MANNINGHAM

COUNCIL MEETING MINUTES

9.1 Application for Review P363/2024 of Planning Application PLN24/0017 for 2
Frederick Street, Doncaster (Amended Plans for VCAT) for the use and
development of the land for a 13 storey residential building comprising 403
dwellings and removal of easements7

Figure: Sectional shadow diagram at 3pm to 9-11 Clay Drive, prepared by Council officers

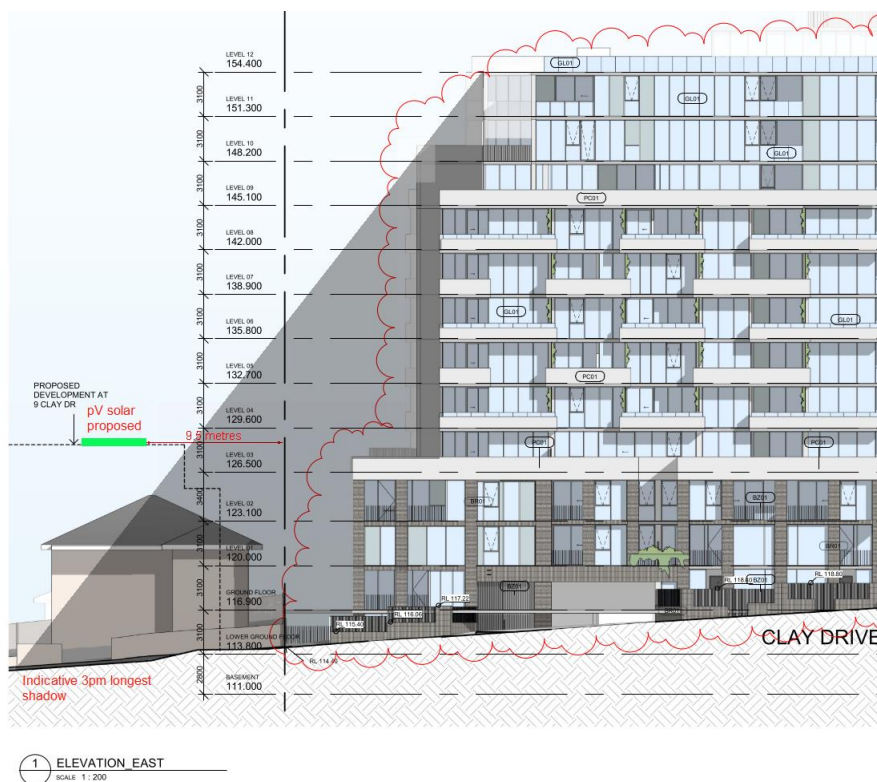
7.29 This is demonstrated by the following sectional shadow diagram, which shows the longest shadows at 3pm would not reach a future apartment rooftop.

7.30 Therefore, the proposal would not reduce the energy efficiency of the future development or any PV solar panels mounted on the roof, and therefore solar access is considered satisfactory.

3 SPRING EQUINOX - 3PM
SCALE 1 : 800

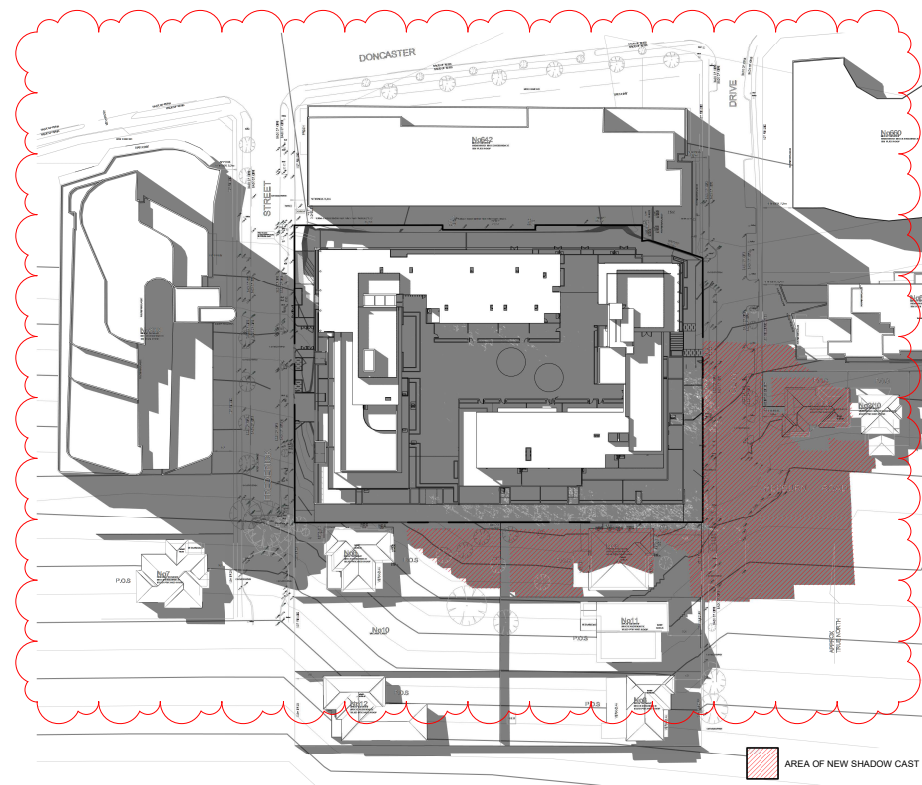
7.26 It is policy under the ACZ1 that *development should be designed to avoid casting shadows on adjacent properties (including public open space areas) outside the activity centre between 11:00am and 2:00pm on 22 September.*

Figure 1 – Green wall example (Source: Google Streetview, image dated Dec 2022).

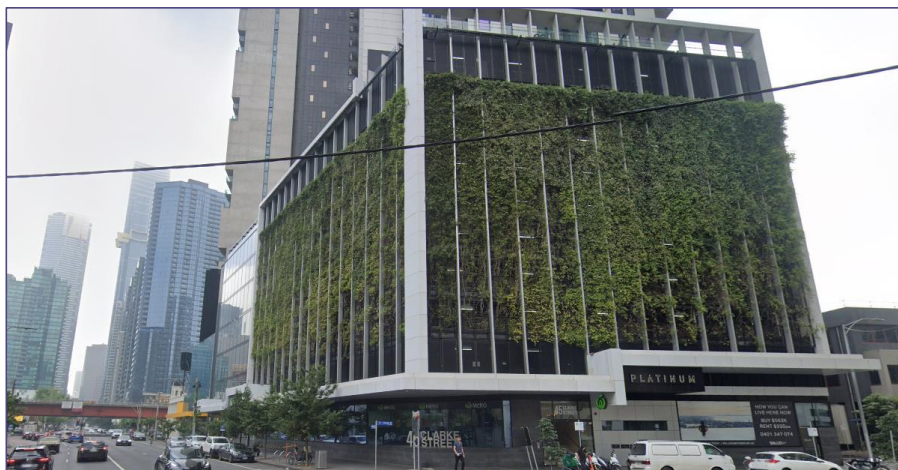
- 4.50 A more practical approach to the green wall planting must be provided to maximise the potential coverage of the built form softening. A contemporary example in Melbourne is the Platinum apartment building at 45 Clarke Street, Southbank. Per the image below (figure 1), the green wall treatment appears to be supported by irrigated planters on each balcony level – which enables the greening to cover more of the building.
